Planning Application Representation

OBJECTION AND COMMENTS ON CLIMATE CHANGE AND NEED ISSUES

Energy from Waste Facility

DM/20/03267/WAS

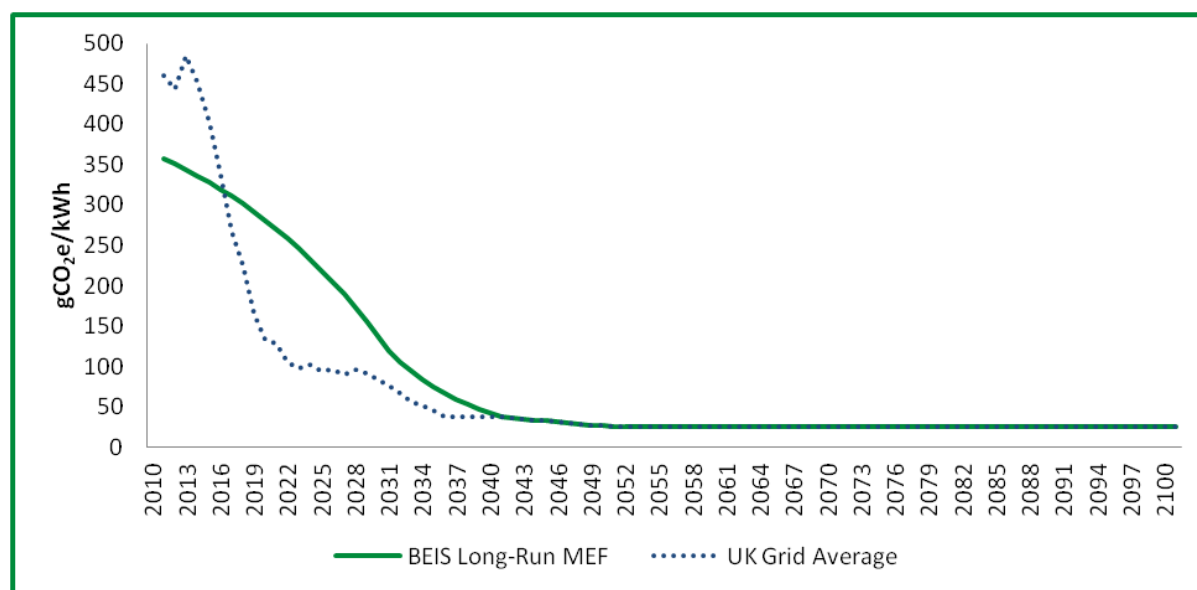
36. The applicant also fails to mention that since the County Durham Plan was adopted in October 2020 planning permission was granted for a 450,000 tonne per annum RDF incinerator at the Redcar Bulk Terminal⁵. This capacity exceeds, by between 305,000 and 383,000 tonnes, the identified capacity gap.

37. The wording at Paragraph 5.586 of the County Plan is clear; the Authority is committed to achieving net and regional self-sufficiency. There is no suggestion that the Authority is eager to welcome overcapacity of residual waste treatment, let alone overcapacity of between 365,000 and 443,000 tonnes.
38. It should also be noted that, as the applicant concedes, the quoted excerpt from the County Plan specifies that: *"additional residual waste treatment/disposal capacity" would only be "looked upon favourably where the proposal is acceptable in all other respects taking into account all relevant Plan policies"*.
39. As there are conflicts with other relevant Plan policies, and as the Consett proposal is accompanied by adverse climate change impacts, the applicant cannot rely on Paragraph 5.586 of the County Plan in support of their proposal.
